Existing ramp to remain.
Holtan Road
Future sidewalk considerations. Existing sidewalk currently dead ends on Holtan Road east of Chapin Lane.

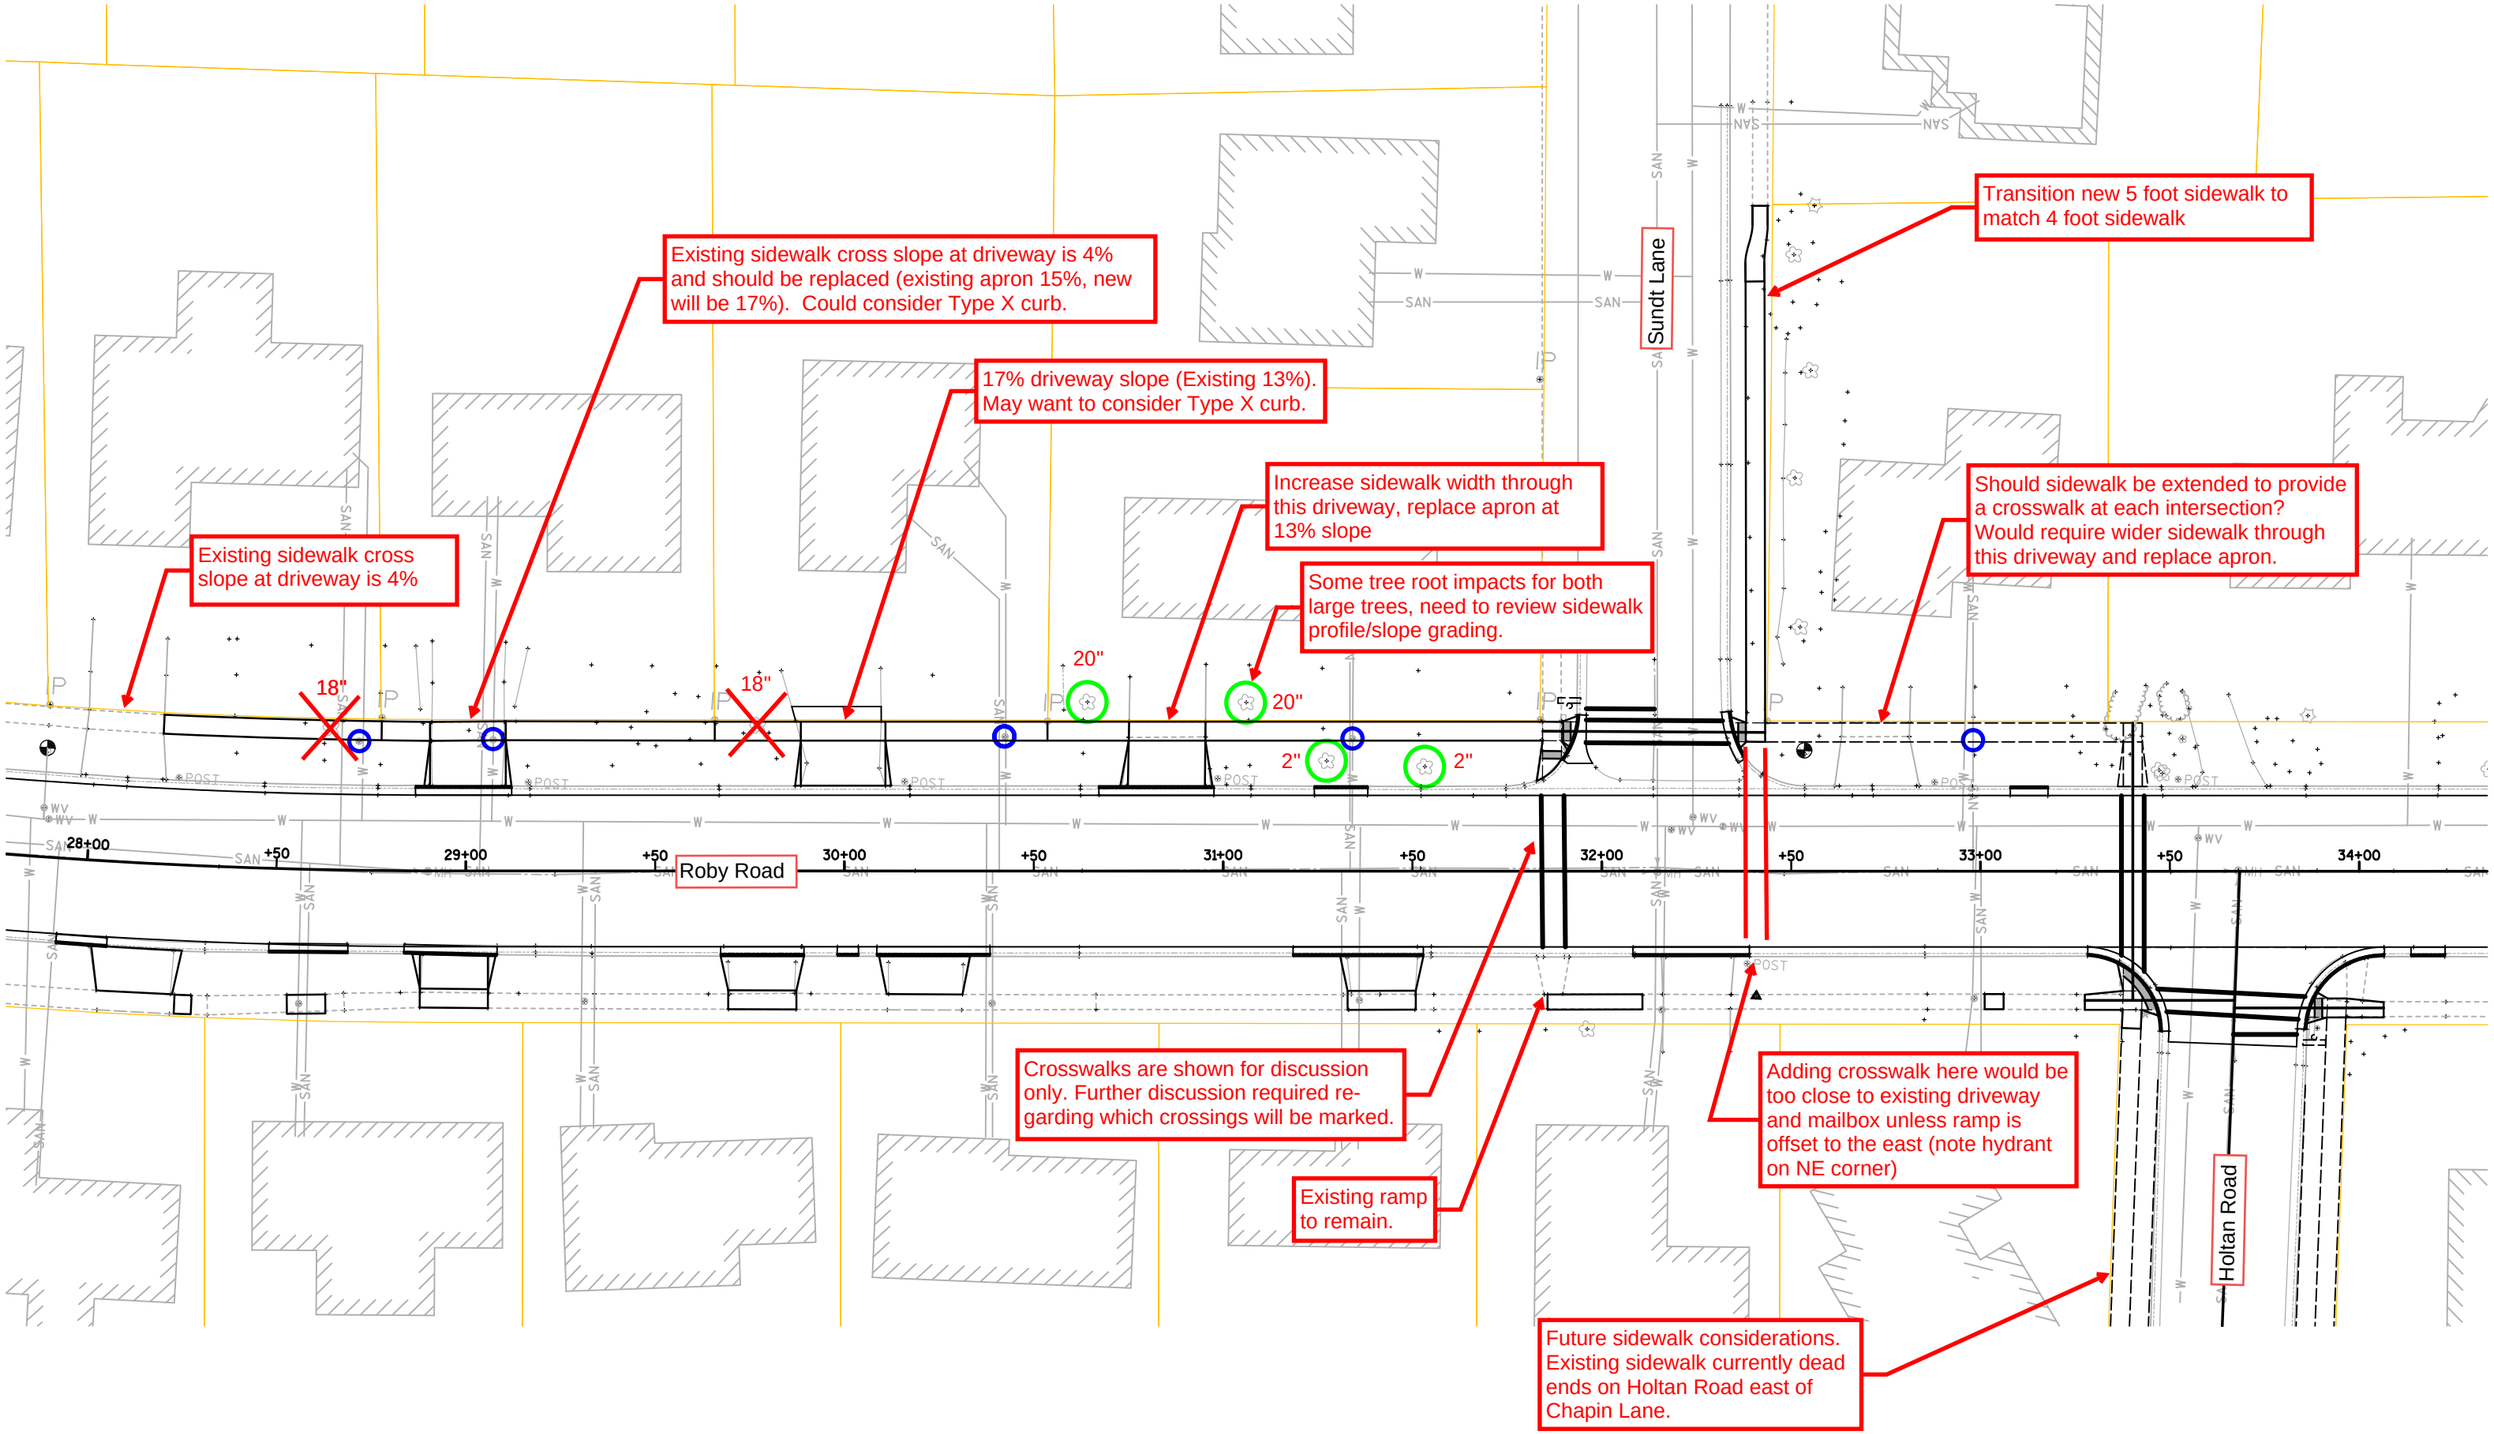
Existing sidewalk cross slope at driveway is 4% and should be replaced (existing apron 15%, new will be 17%). Could consider Type X curb.
17% driveway slope (Existing 13%). May want to consider Type X curb.
Transition new 5 foot sidewalk to match 4 foot sidewalk
Increase sidewalk width through this driveway, replace apron at 13% slope
Should sidewalk be extended to provide a crosswalk at each intersection? Would require wider sidewalk through this driveway and replace apron.
Existing sidewalk cross slope at driveway is 4%
Some tree root impacts for both large trees, need to review sidewalk profile/slope grading.
Sundt Lane
18"
18"
20"
20"
2"
2"
28+00
29+00
30+00
31+00
32+00
33+00
34+00
Roby Road
Crosswalks are shown for discussion only. Further discussion required regarding which crossings will be marked.
Adding crosswalk here would be too close to existing driveway and mailbox unless ramp is offset to the east (note hydrant on NE corner)
